FINAL DRAINAGE REPORT

CLAREMONT BUSINESS PARK
FILING NO. 2, LOT 2-1A

EL PASO COUNTY, COLORADO

Project #44-034
PCD FILE NO. PPR192

Detention Basin Outlet Structure Design

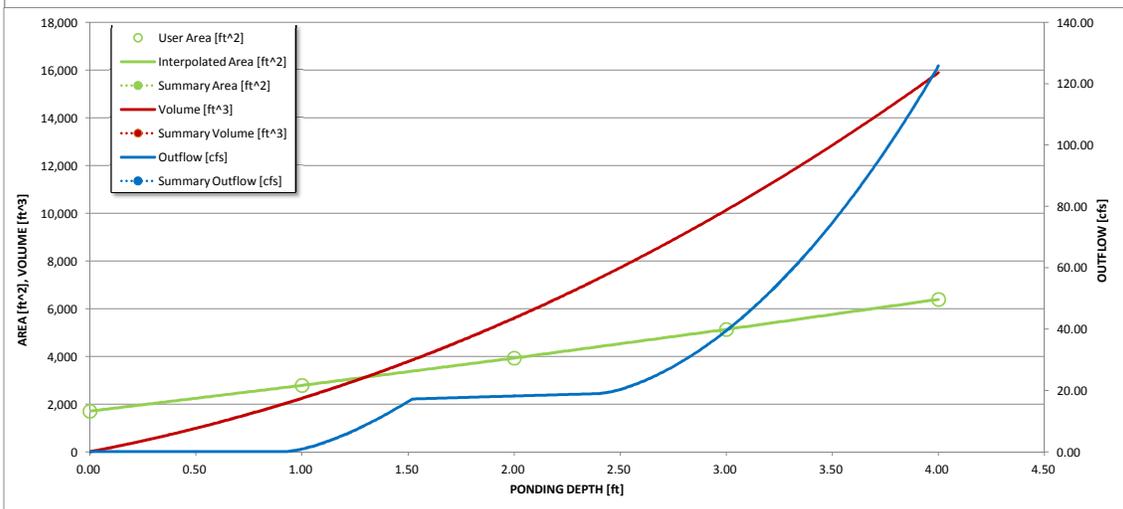
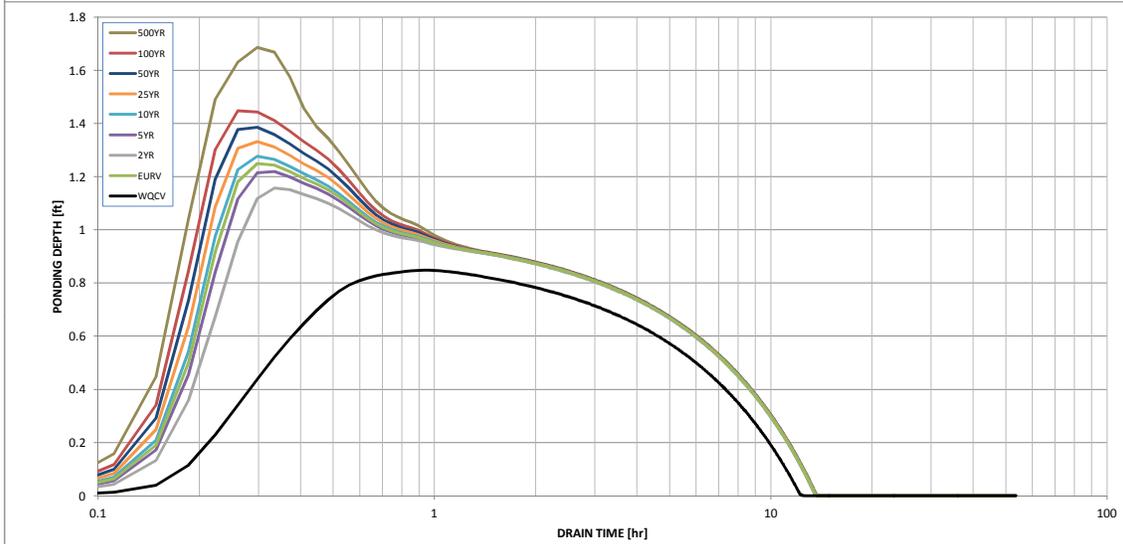
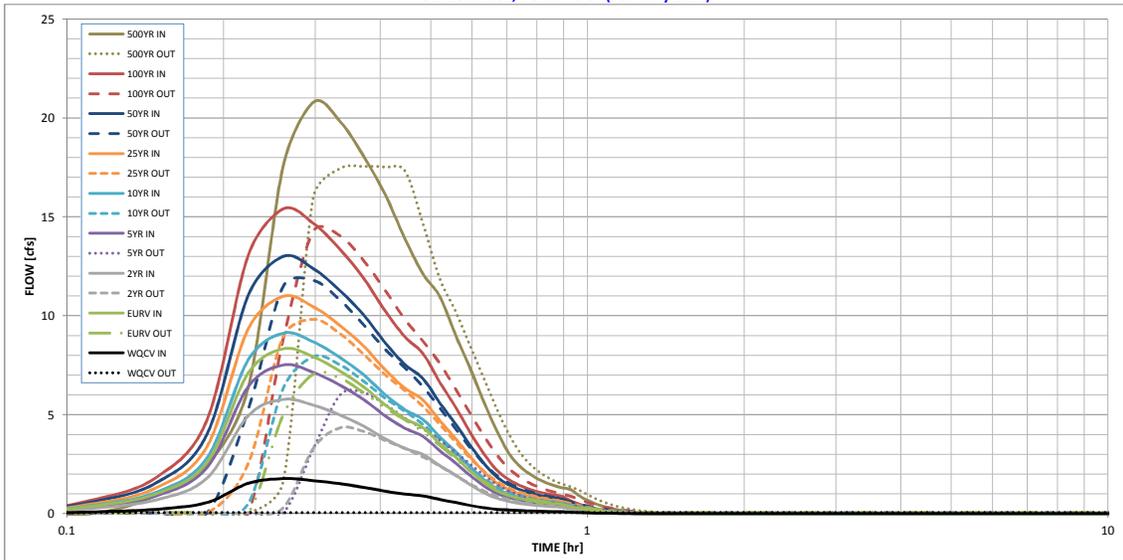
This calculation does not indicate the size/type of riprap required. Additionally, the drainage plan indicates a trapezoid shaped rundown. Revise accordingly so that they match.

This calculation does not indicate the size/type of riprap required. Additionally, the drainage plan indicates a trapezoid shaped rundown. Revise accordingly so that they match.
